## PRIVATE WATER DISTRIBUTION SYSTEM IMPROVEMENTS

# GRACEMED - PROJECT OASIS

**AS BUILTS**

## WATER PLAN AND PROFILE

PLAN WTR LINE 1

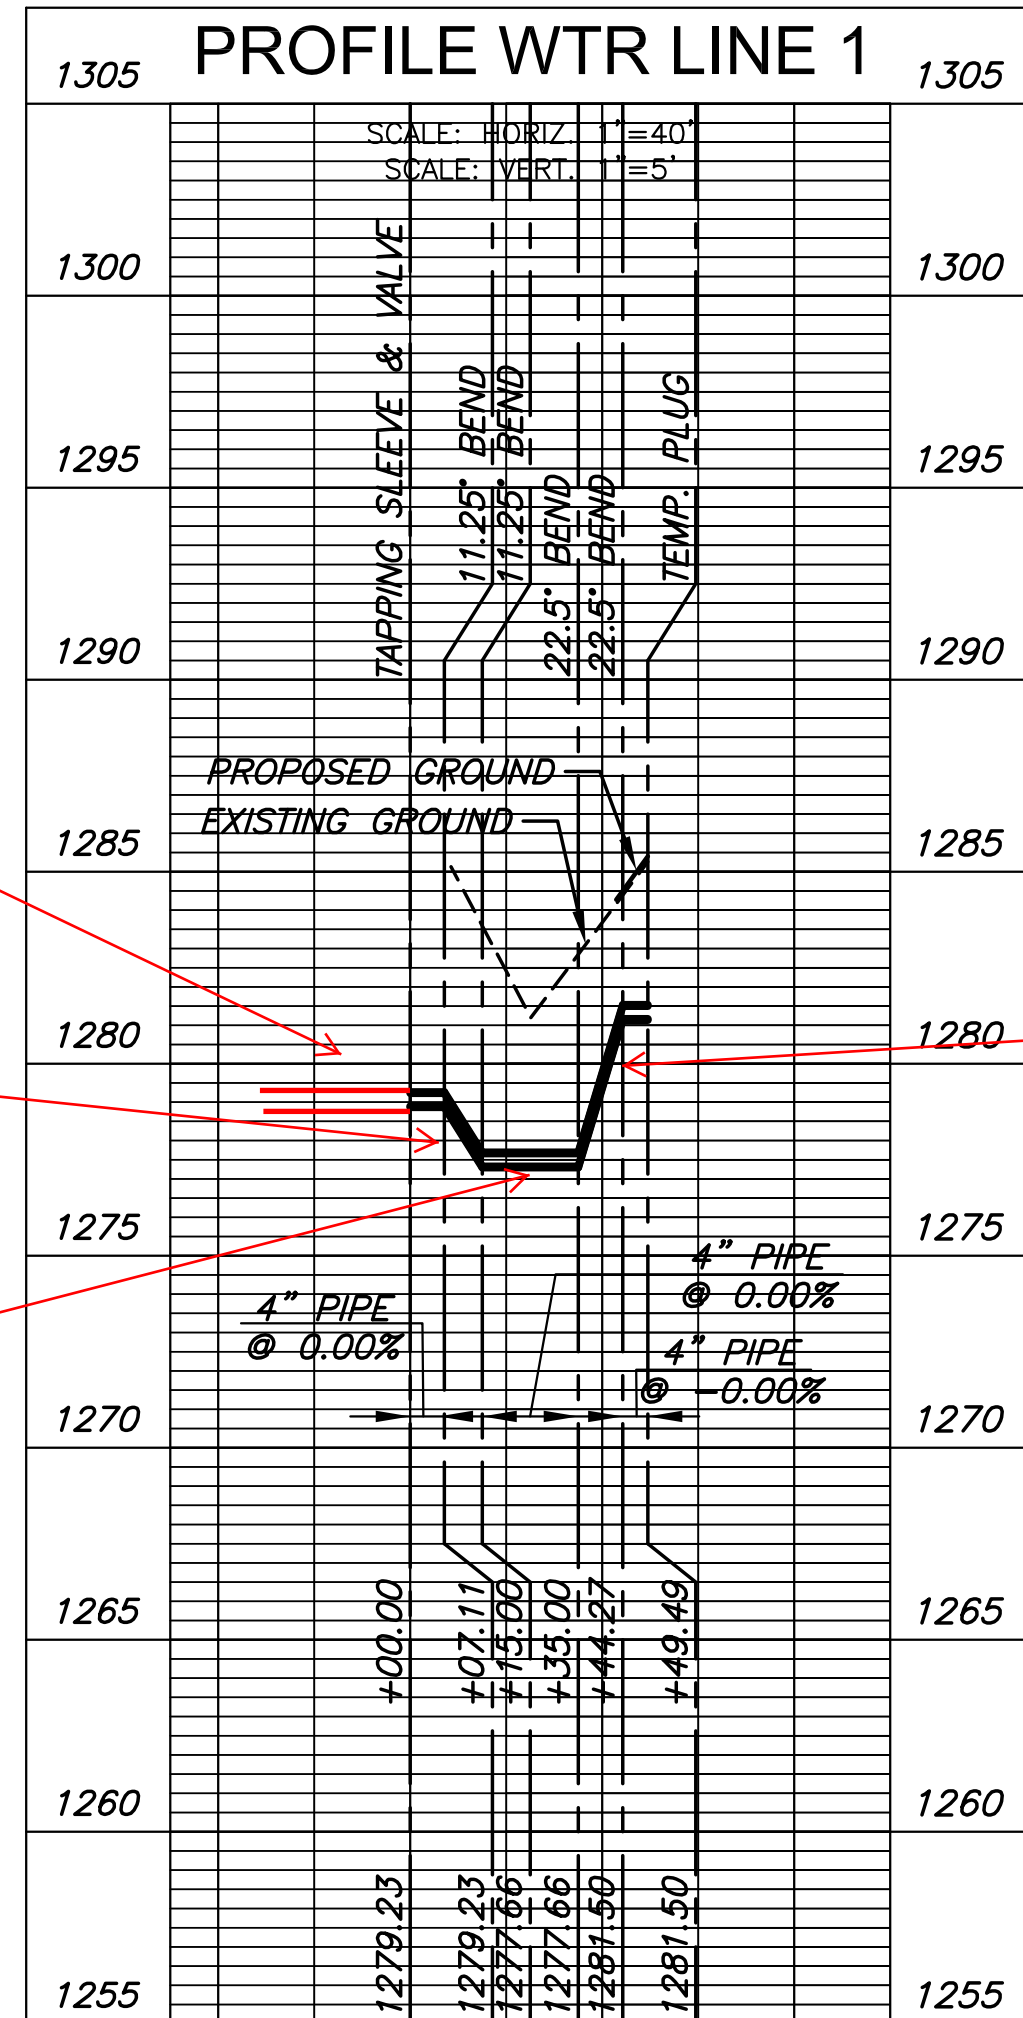
33 RD ST. & Richmond center of 33 RD ST. and center of Richmond 12' East on 33RD and 25' South to valve

Tapping valve 16'2" of C-900 111/4 deg. bend 3" dicl 4" 19'6" C-900 221/2 deg. bend 10' of dicl 221/2 deg. bend 6'9" of dicl

All fittings and bends were megaluged

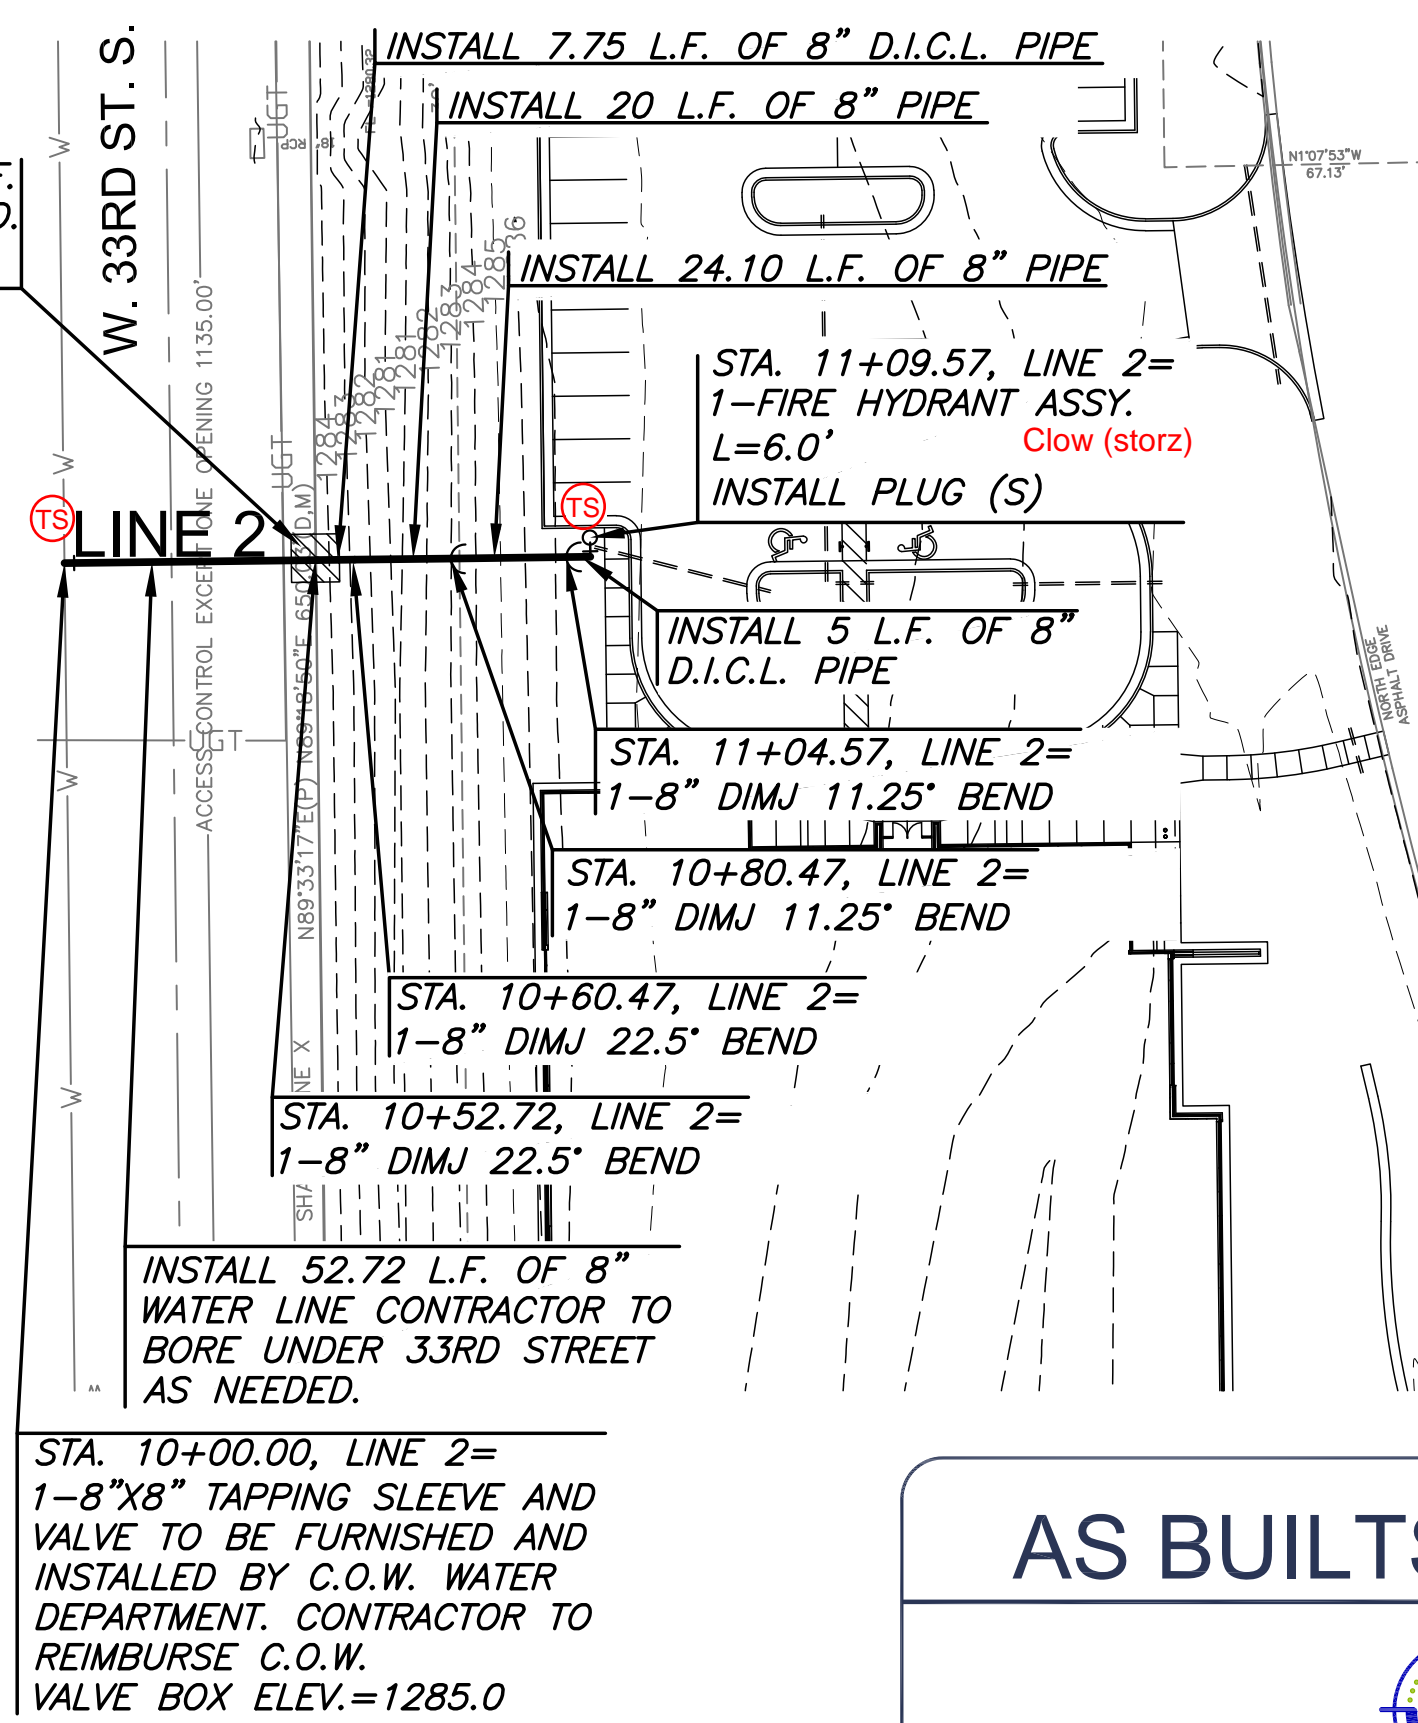
tapping valve 16'2" pvc 111/4 bend

3' of dicl 19'6" pvc 221/2 bend

10' dicl 221/2 bend

PLAN WTR LINE 2

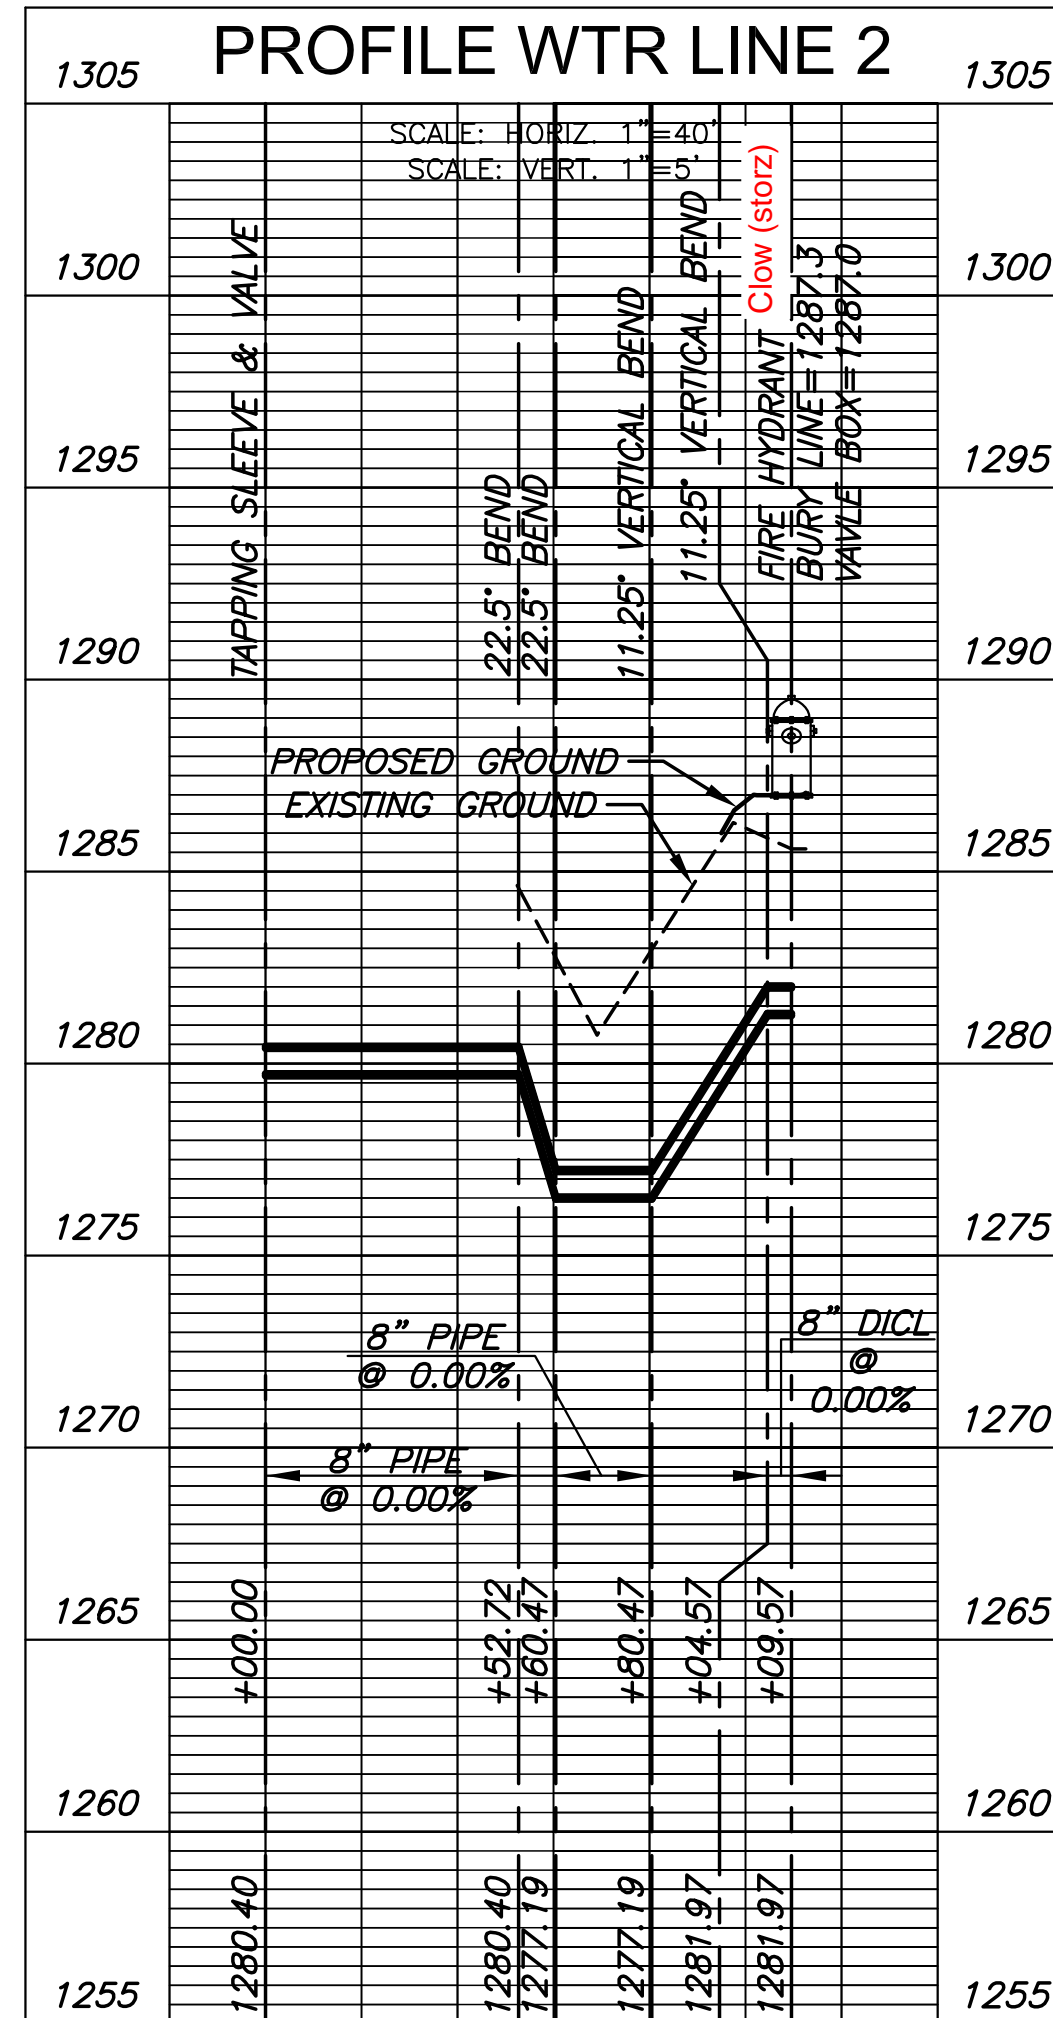
Center of 33rd & Richmond 195.5' East & 18' North to valve

Tapping sleeve valve 50' of C-900R 221/2 deg. bend 7.75' dicl 221/2 deg bend 14' of C-900 111/4 deg. bend 24'2" pvc 111/4 deg. bend 9'8" pvc Fire Hydrant Assy. Tee & valve Plug in tee 6' dicl fire hydrant Clow(storz)

All fittings and bends were restrained with megalugs
